APPLICATION NO.	FILING DATE	FIRST NAMED INVENTOR	ATTORNEY DOCKET NO.	CONFIRMATION NO.
10/645,274	08/21/2003	Pierre Michiels	84620-0019	7235

Office Action Summary

This is a first office action for serial number 10/645274, entitled Device for equipping an expansion joint, in particular an expansion joint between concrete slabs, filed on August 21, 2003.

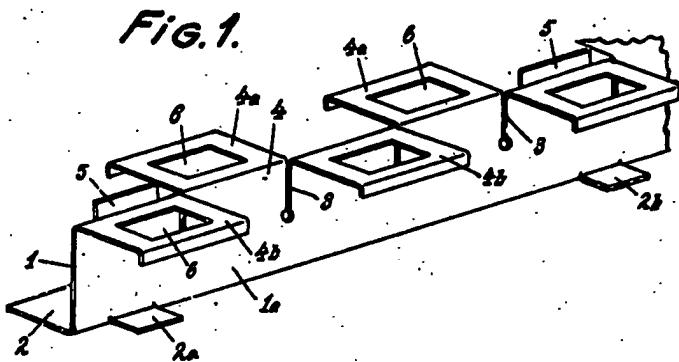
Musall discloses the claimed invention including a device (figure 1) wherein said device is constituted by an assembly of two modules (at 4) derived from sheets, each of the modules comprising: a first series (by 3) of flat elements (at 1), which form projections (4a, 4b), a second series (at 2) of elements in the form of a right angle (figures 2 and 3), which are integral with said projections (4a, 4b), said elements in the form of a right angle (at 2) comprising a first flat part (at 2), which is in the same plane as said projections (4a, 4b), and a raised second flat part (2b), which forms a right angle with said first part (at 2), flat elements (1), which are in the same plane as said raised parts (2b) and which form connections in the form of first longitudinal members (attached figure 3) between said raised parts (2b); flat elements (2) which are in the same plane as said projections (4a, 4b) and form connections in the form of second longitudinal members (see attached figure 2), each second longitudinal member being present between the ends of one of said projections (at 3) and of one of said first parts (2), being situated in the same plane as said projections (2 and 4a, 4b); a separating element (interpreted to be 5), such as a foil sheet, between the two modules (4).
